TO: St. Francis Planning Commission
FROM: Beth Richmond, Consulting Planner
SUBJECT: Dalton River Villas Concept Review
DATE: 6-11-2025 for 6-18-2025 meeting
APPLICANT: Meadow Creek Construction (Mike Pomerleau)
LOCATION: PID 32-34-24-24-0069
COMP PLAN: Low Density Residential and Park/Open Space
ZONING: R-1 Urban Low Density Detached Residential

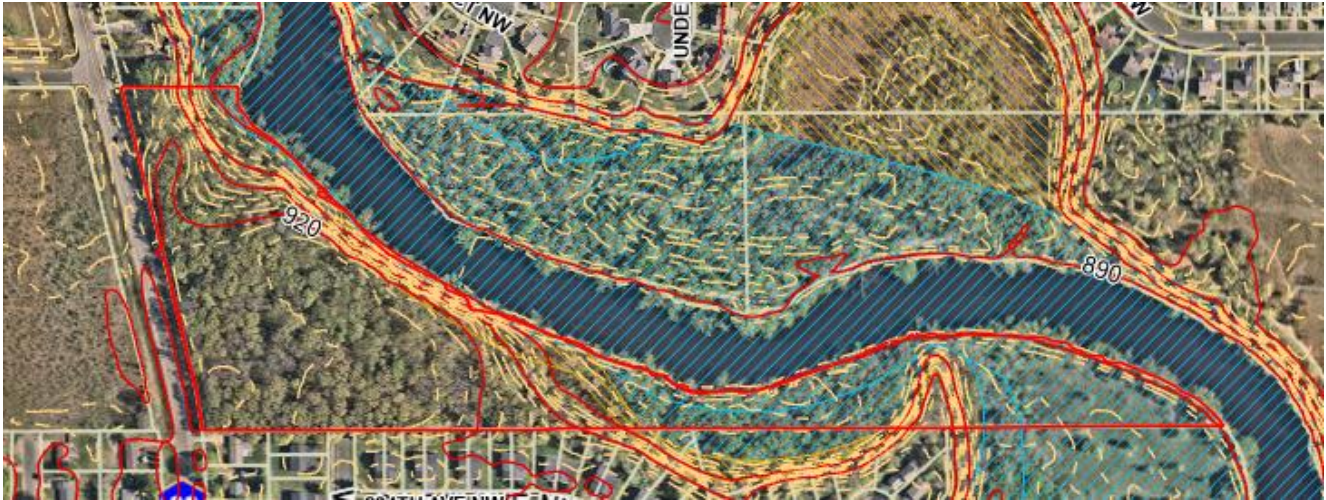
The concept proposes lots which are undersized in lot area, lot width, and which do not meet the front setback requirement for the uRRM overlay district. 8 of the proposed lots meet the R-1 lot area requirement of 10,800 sq. ft., while 6 lots meet the uRRM requirement of 12,150 sq. ft. None of the lots meet the required 90-ft. lot width of the uRRM – 15 lots are proposed to be 65 feet wide and 4 lots are proposed to be 55 feet wide. Variances or a PUD would be required in order to allow the flexibility shown on the concept. Because the site is within the uRRM overlay district and therefore would require DNR approval for any variance or ordinance amendment, the City has notified the DNR of the concept and requested their feedback. No comments have been received as of June 9.

Staff supports the design of this concept. The wide east/west nature of this lot, coupled with the existence of the floodplain, bluff, and County Road, create challenges when it comes to designing a development that preserves the natural features of the site while efficiently utilizing City infrastructure. While the lots are smaller than required, the overall density of the site is considerably less than what would be allowed if the site was unencumbered. The proposed lots are similar in size to the existing lots in the neighborhood directly to the south, promoting a cohesive neighborhood throughout the area.

An outlot is proposed along the Rum River which encompasses the floodplain area and the bluff. This outlot would also include the stormwater pond for the development. As part of a future application, the applicant would need to identify the owner for the outlot and provide the City access to the stormwater pond from the Woodbine St NW extension. The Planning Commission should discuss whether the City would be interested in owning this outlot. The City owns the open space along the river directly to the south of this outlot. It may make sense for the City to also take ownership of this outlot so that the two could be connected.

Street access to 16 of the 19 lots is proposed to come from an extension of Woodbine St NW. Woodbine St NW is currently constructed up to the south property line of the site. The concept shows the Woodbine St NW extension ending in a cul-de-sac. Staff and the applicant have discussed the possibility of connecting Woodbine St NW through to Ambassador Blvd NW instead of creating a cul-de-sac. Because Ambassador Blvd NW is a County Road, the County would have the final say on that possibility. Staff is supportive of either option but feels that the cul-de-sac option is more likely to be supported by the County based on Anoka County's street spacing guidelines.

Within the City, cul-de-sacs are allowed a maximum street length of 750 feet in the Urban Service Area and may serve the maximum density allowed by State Fire Code (30 units or less according to D107 of the Minnesota State Fire Code). The proposed cul-de-sac is anticipated to be less than 750 feet long and would serve 20 units including those already constructed in the development to the south.

Three of the proposed lots are shown to have access directly onto Ambassador Blvd NW. As an A Minor Collector, it is unlikely that Anoka County will allow additional access points onto Ambassador. If that is true, the applicant would need to adjust the concept to eliminate the access points onto Ambassador. This could be done through the use of shared driveways, lot reconfiguration, or the elimination of up to three lots.

1. Flexibility would be requested from the lot area, lot width, and setback requirements for the uRRM and R-1 districts. Flexibility is typically granted with a variance or by creating a Planned Unit Development. Does the Planning Commission prefer one route over another?

2. Should the City consider owning the outlot containing the bluff and floodplain? If the city takes ownership, would it be managed as part of the city park system?
